From: Jacobson - DNR, Eric <eric.jacobson@state.co.us>
Sent: Friday, December 24, 2021 7:17 AM
To: Brian Stanley
Cc: Jason Eisenach
Subject: [External]:Re: [External]:Re: Mile-Hi Duck Club Pascoe #1 CBL (05-001-06992)

From: Brian Stanley <BStanley@VerdadResources.com>
Sent: Tuesday, December 21, 2021 4:48:32 PM
To: Jacobson - DNR, Eric <eric.jacobson@state.co.us>
Cc: Jason Eisenach <jeisenach@phxresources.com>
Subject: Mile-Hi Duck Club Pascoe #1 CBL (05-001-06992)

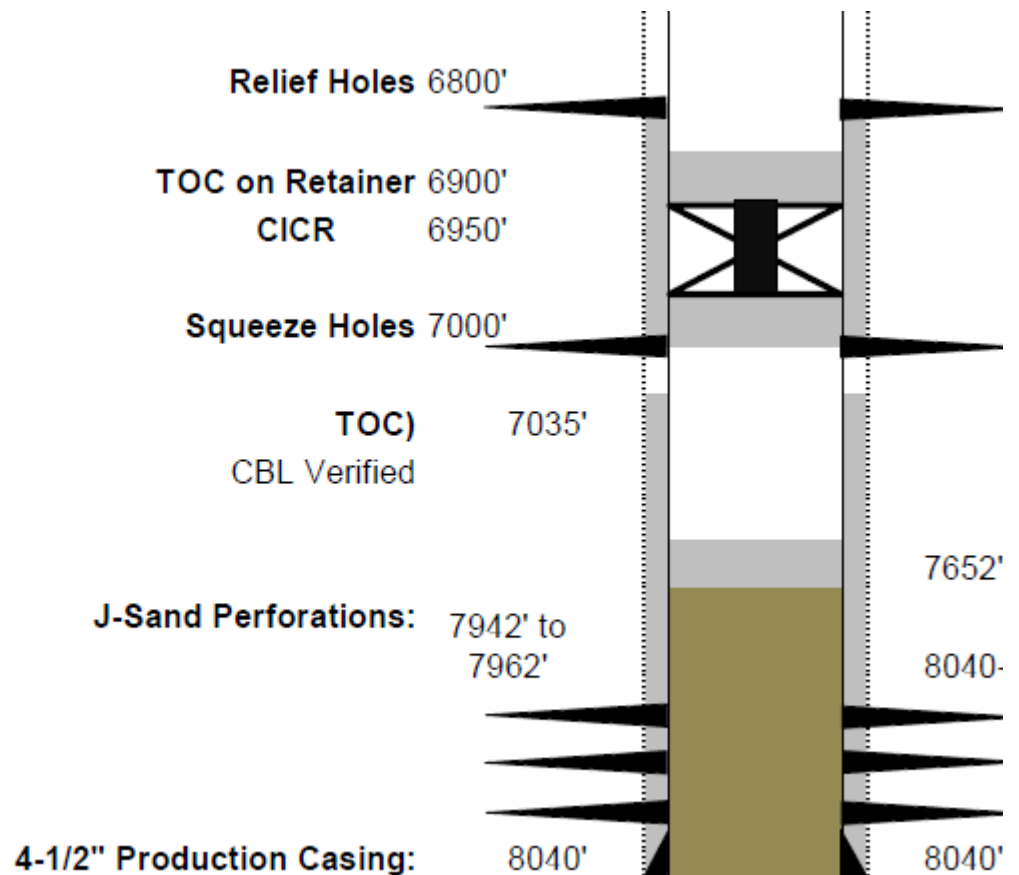
After reviewing the CBL, I would make one change on the lower plug.

Perforate at 7000' and pump 50 sacks of cement leaving 100' in the casing.

The rest of the plugs look good.

Something like this? Full WBD attached as well.
